SUBJECT: Change to package with Side castellations

PCN # 35_2018

Part number: RV-1805-C3

New package:

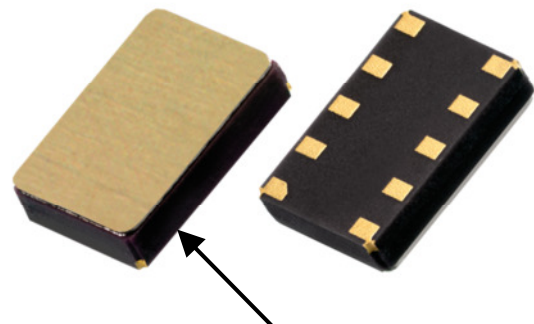
Enhanced package outline to enable optical post soldering inspection.

The contacts are enhanced in such a way to be present also on the vertical side-castellations of the package. During soldering small meniscus are formed automatically. These will be visible and will allow optical soldering inspection

Fit, Form , Function as well as electrical parameters and software functionality are identical. There is principally no need for requalification. Special attention: The Reset output function is now fully meeting specification.

Package Drawing:

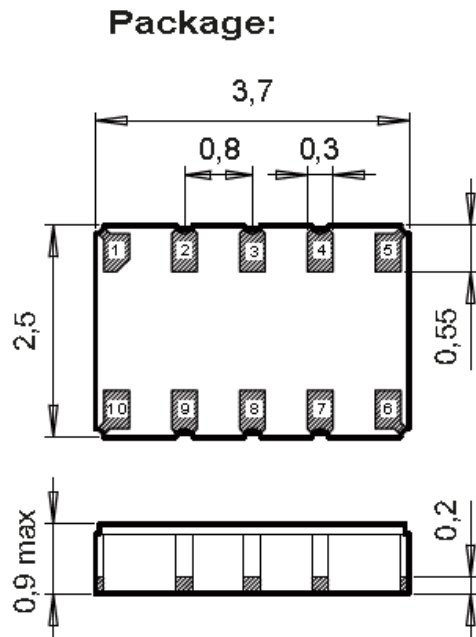
Mechanical outer dimensions of RV-1805-C3 are kept the same. However the contacts are enhanced to be present also on the vertical sides of the package. The dimensions of the recommended solder pad layout did not change.
